**STAFF RECOMMENDATION**  
**110 Third Avenue South**  
**November 16, 2016**

**Application:** Signage and Alterations  
**District:** Broadway Historic Preservation Zoning Overlay  
**Council District:** 19  
**Map and Parcel Number:** 09306405700  
**Applicant:** Daley Smith, Kennon Calhoun Workshop  
**Project Lead:** Melissa Sajid, [Melissa.sajid@nashville.gov](mailto:Melissa.sajid@nashville.gov)

**Description of Project:** The application proposes a new canopy sign, and the request includes a modification to allow a portion of the sign exceed the maximum height of two feet (2') and to extend beyond the edge of the canopy. The application also includes alterations to the non-contributing façade that include converting the existing loading area to a storefront with canopy and changes to the upper-story windows. The rooftop addition and a new storefront were approved prior to the expansion of the overlay to include this building.

Figure 2: Canopy sign location

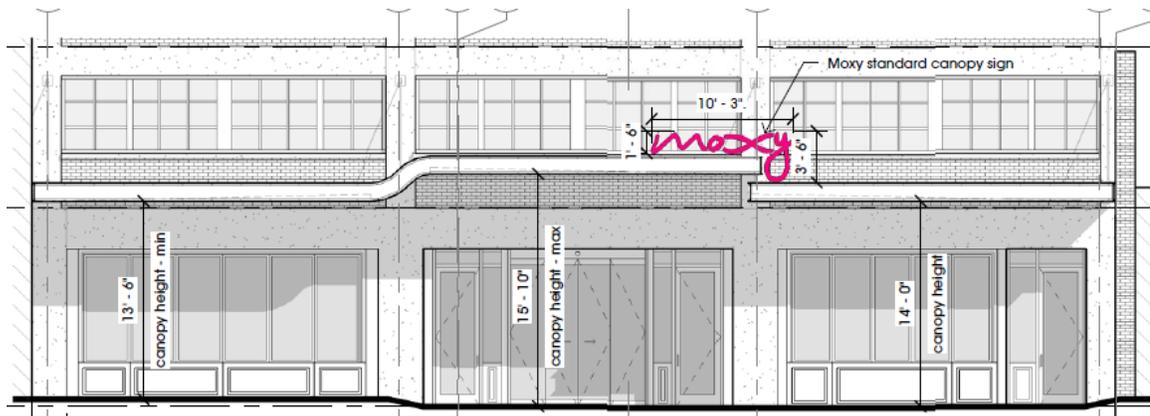
Location: The signs will be located above the entrance to the building. The majority of the sign is located above the canopy with the letter "y" extending below the canopy (Figure 2.). Section IV of the design guidelines states that "a canopy sign cannot extend outside the overall length of width of the canopy. However, a canopy sign may extend above or below the canopy provided the sign meets all other design standards." Staff finds that, with approval the requested modification for the height of the text, the sign does meet all other design standards and that the location of the "y" on the sign is appropriate as it is only a small portion of the sign. In addition, the proposed sign does not cover windows or architectural details.

Staff recommends approval of the canopy sign and associated modification, finding that the project meets Section IV of the design guidelines.

**1** Elevation - 3rd Ave  
1/8" = 1'-0"

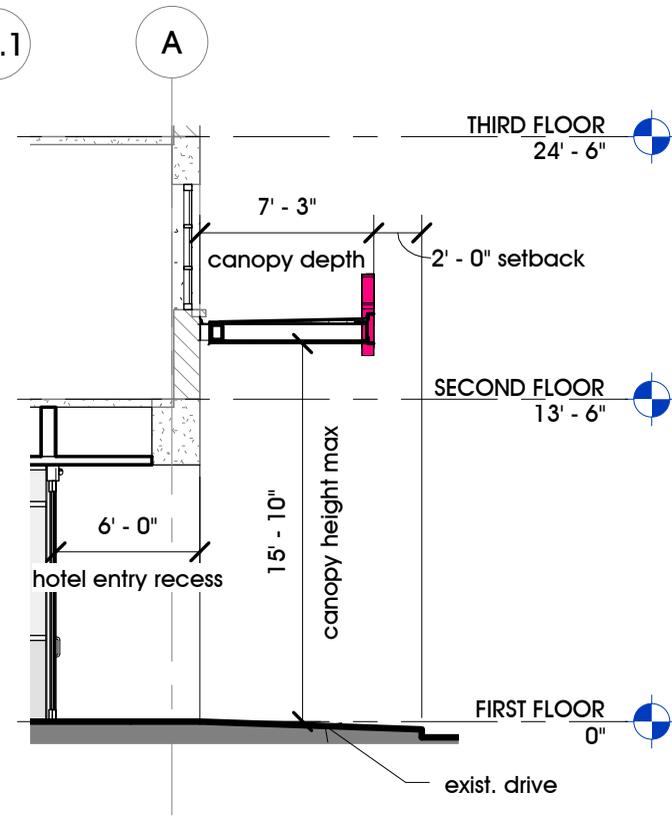
**Storefront Alterations:** The applicant plans to alter the existing façade which currently includes two pull-in loading bays and a small storefront on the left. The plans include creating a central entrance with storefront windows, installing a full length metal canopy between the first and second stories, and replacing the upper-story windows. The existing storefront is not historic and changes to the storefront were permitted in 2014 before this lot was included in the Broadway HPZO. The storefront changes proposed with this application are different from those that were permitted in 2014.

The plan proposes to replace the existing loading bays and small storefront with a new storefront that includes a central entrance with an entry on the far right side of the façade. The new storefront will include large windows with full-light sliding doors and single doors. The storefront windows will include a metal panel bulkhead, and the doors will include either single-light glass or metal transoms. The windows and doors will be insulated aluminum. The contemporary design and materials are appropriate for this building that likely never had a traditional wood and glass storefront. With the condition that staff approve the window and door selections prior to purchase and installation, staff finds that the proposed changes to the storefront including the materials for the transoms and bulkheads are appropriate since the storefront is not historic.

The application also proposes to replace the existing steel multi-light windows on the upper stories with insulated aluminum multi-light windows. The existing concrete and brick façade above the storefront and on the upper levels will remain. Because the existing storefront is not historic and the new windows are similar to historic industrial windows found in the district, staff finds these proposed changes to be appropriate.

A two-part metal canopy is proposed above the storefront, below the second story windows. As proposed, the canopy will not obscure any windows or architectural features. Staff finds that the location and materials of the canopy meet the design guidelines.

Staff finds that the proposed changes to the storefront at 110 Third Avenue South meet Sections II.A., II.B., II.C., II.D., II.E., II.F., and II.I. of the design guidelines for rehabilitation of storefronts, doorways and entries, display windows, transoms, bulkheads, and canopies.

GRAPHIC DETAIL  
SCALE = 3/4" = 1'-0"

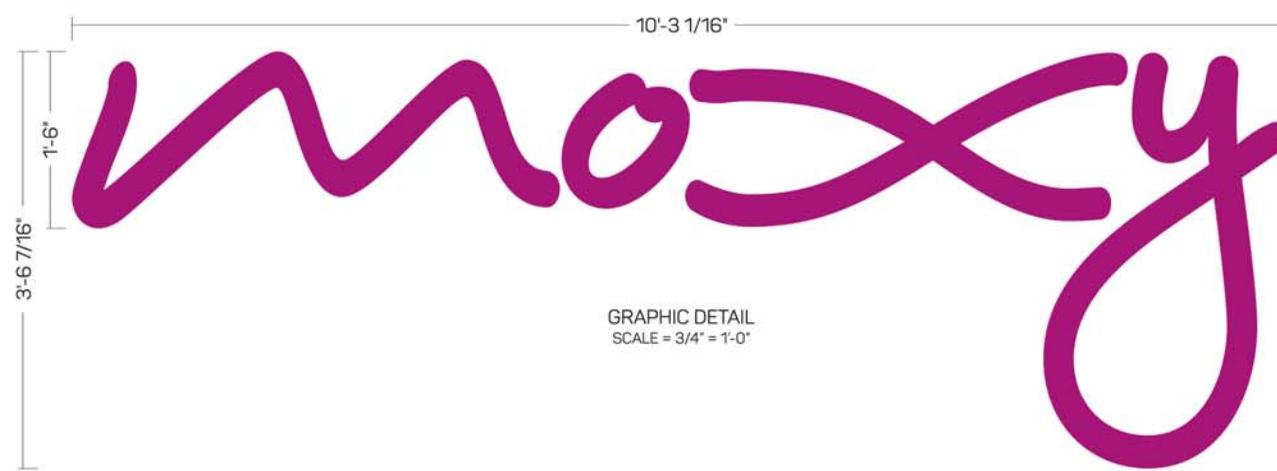
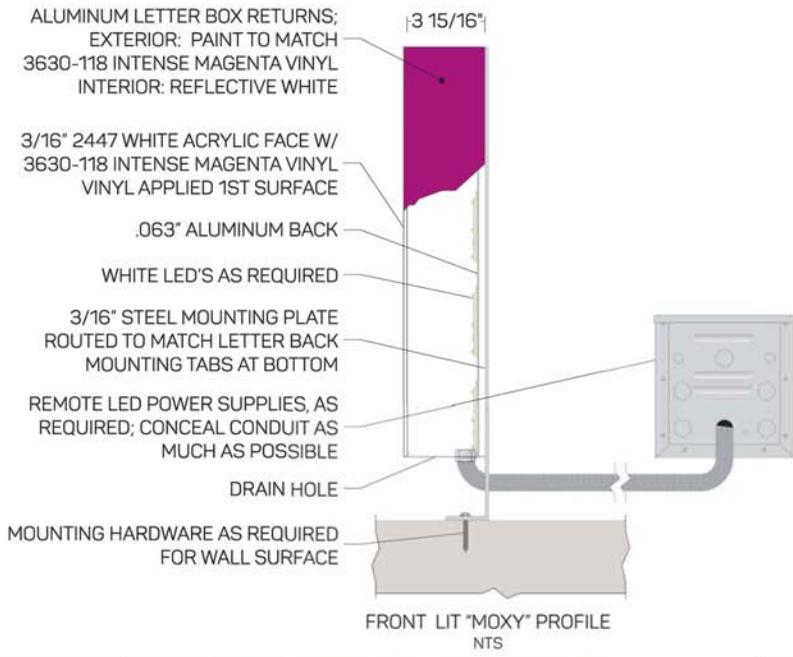
The maximum height of the text and/or graphics of the canopy sign is two feet (2') per the design guidelines. As proposed, the majority of the sign is one foot, six inches (1'-6") in height; however, the "y" is approximately three feet, six inches (3'-6") tall which exceeds the maximum height for the text. The applicant has requested a modification to permit the height of the sign as proposed, and staff finds that the modification is appropriate as it only applies to a small portion of the sign. In addition, the portion of the sign subject to the modification is located at a break in the canopy, and the continuation of the canopy after the break begins below the "y". This break helps to minimize the impact of the additional height of the letter. For these reasons, staff recommends approval of the requested sign modification.

The depth of the canopy sign will be approximately four inches (4") which does not exceed the maximum depth of thirteen inches (13") per the design guidelines.

**Materials:** The canopy sign will be painted aluminum and will not include an exposed raceway. This project meets the design guidelines for signage materials.
